Our ref: 110865/AT/001

PL/2026/02458 – Lidl Eastern Way, Melksham Transport and Highways

**EASTERN WAY -
PROPOSED ACCESS
ARRANGEMENT**

Name	Date	Scale	1:500 @ A1
Drawn	EF	JAN 2026	File No.	110865-PEF-XX-XX-DR-C-001001.dwg
Designed	EF	JAN 2026	Drawing Status	FOR INFORMATION
Checked	AJT	JAN 2026	Revision	
Approved	LC	JAN 2026		
Drawing No.	110865-PEF-XX-XX-DR-C-001001			
				P03

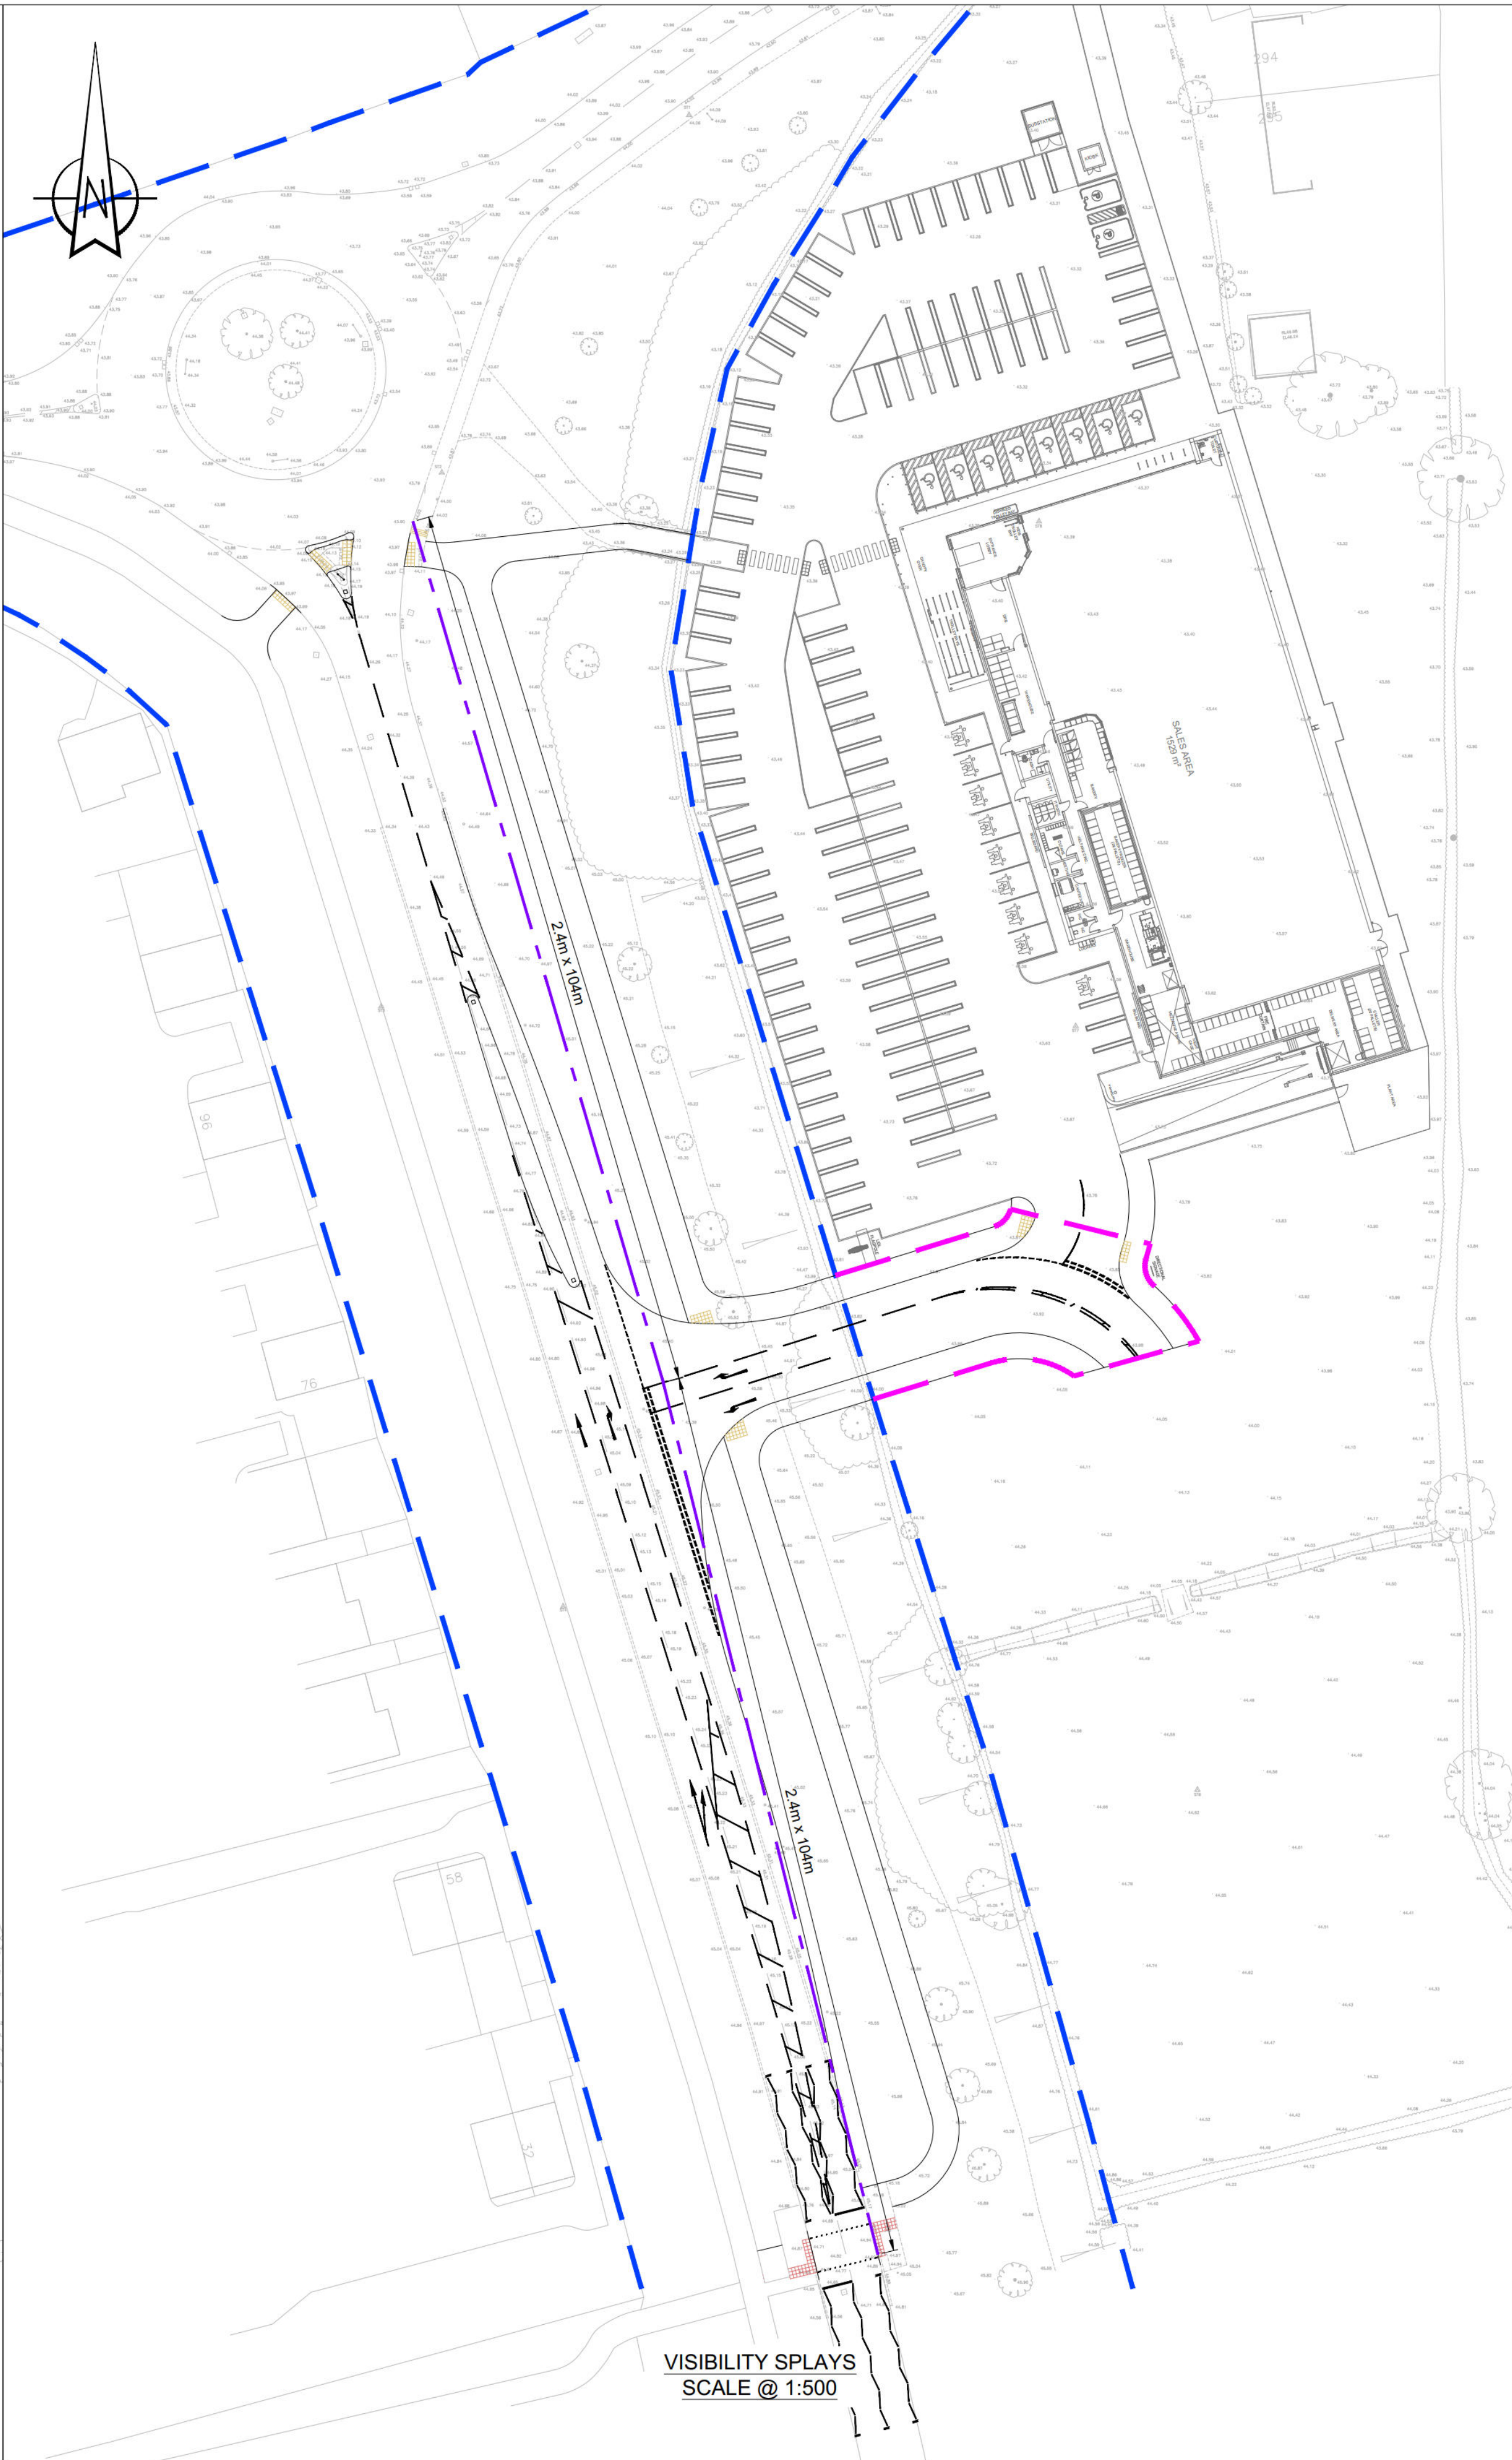
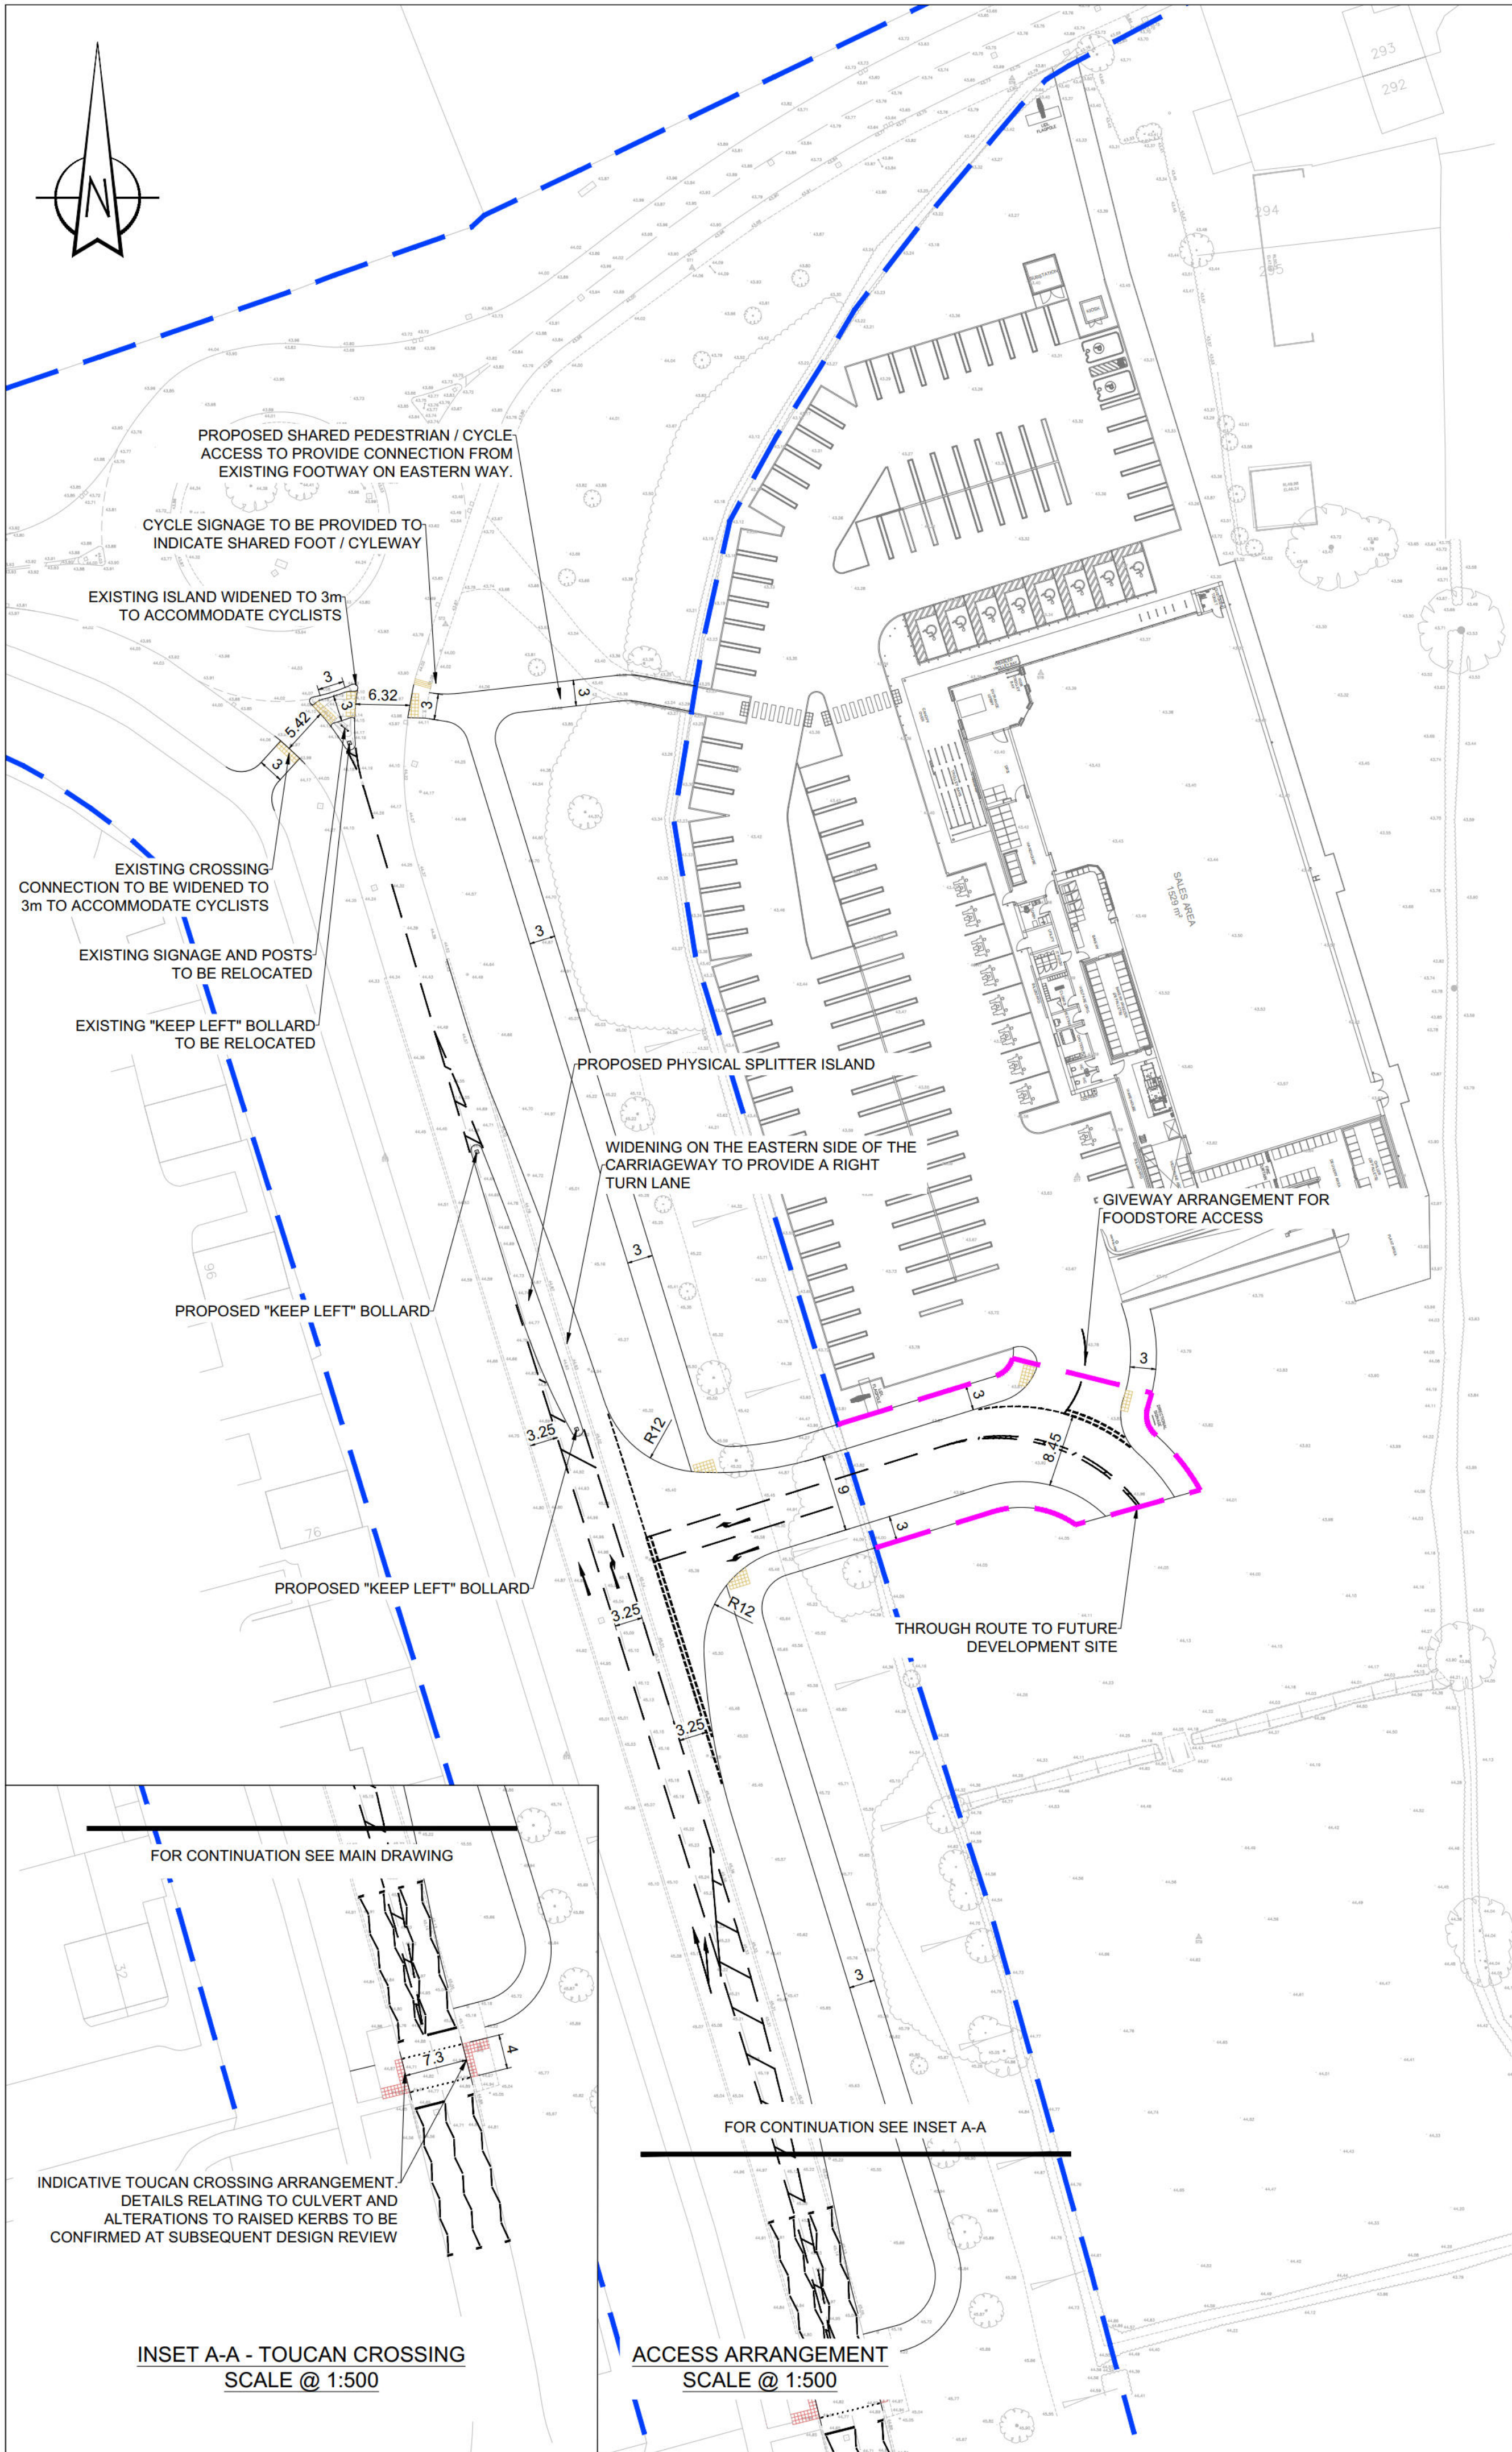
Regarding the request for a physical splitter island to be provided on the northern side of the right turn lane, we note that this was not raised as an issue in the independent Stage 1 Road Safety Audit. However, we have updated the design to include a splitter island as requested. This is shown on Drawing 110865-PEF-XX-XX-DR-C-001001-P02 enclosed with this letter.

We have also updated the design to include the crossing on the splitter island on the southern arm of roundabout to be widened to 3m in order to accommodate cyclists, as requested. The proposed alterations to the island and crossing points are shown on Drawing 110865-PEF-XX-XX-DR-C-001001-P03 enclosed with this letter.

P03	Updated to suit Highway Comments	EF	AJT	LC	10.08.2026
P02	Proposed Highway Boundary Added	EF	AJT	LC	06.03.2026
P01	First Issue	EF	AJT	LC	15.01.2026
REV	DESCRIPTION	DRN	CHK	APP	DATE

Name	Date	Scale	1:250 @ A1
Drawn	EF	JAN 2026	File No.	110865-PEF-XX-XX-DR-C-001002.dwg
Designed	-	-	Drawing Status	FOR INFORMATION
Checked	AJT	JAN 2026	Revision	P02
Approved	LC	JAN 2026		
Drawing No.	110865-PEF-XX-XX-DR-C-001002

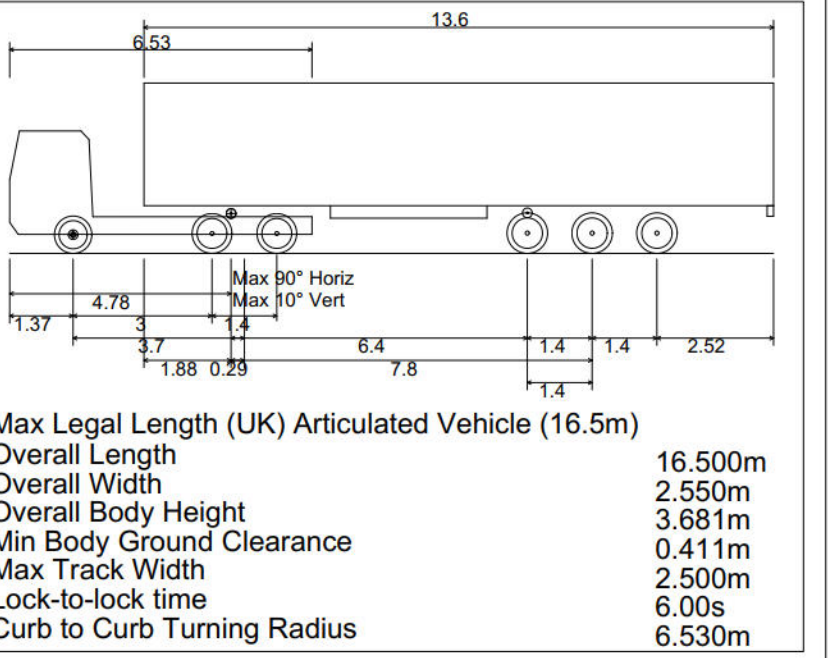
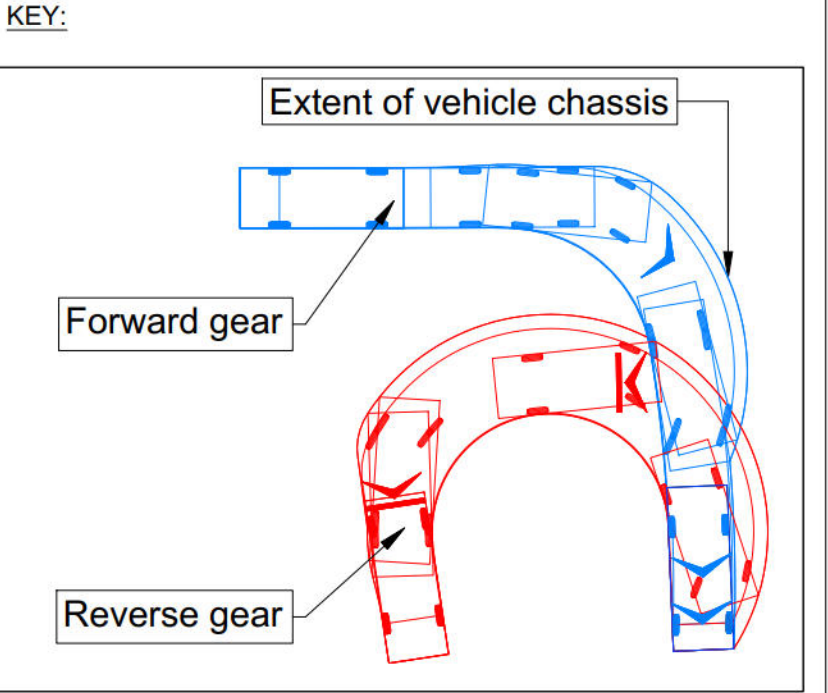
On the point relating to the length of the proposed parking bays within the car park, it is noted that the central parking bays are shown at 5.2m long on the site layout plan and the bays on the boundaries are shown as 4.7m long. Given the aisle widths available, increasing the length of the bays on the car park boundary would not be an issue and the bays will be constructed with a minimum length of 4.8m. This will not affect the swept path analysis provided for the delivery vehicle on the basis the central parking bays are 5.2m long.

P02	Updated to suit Highway Comments	EF	AJT	LC	10.08.2026
P01	First Issue	EF	AJT	LC	15.01.2026
REV	DESCRIPTION	DRN	CHK	APP	DATE
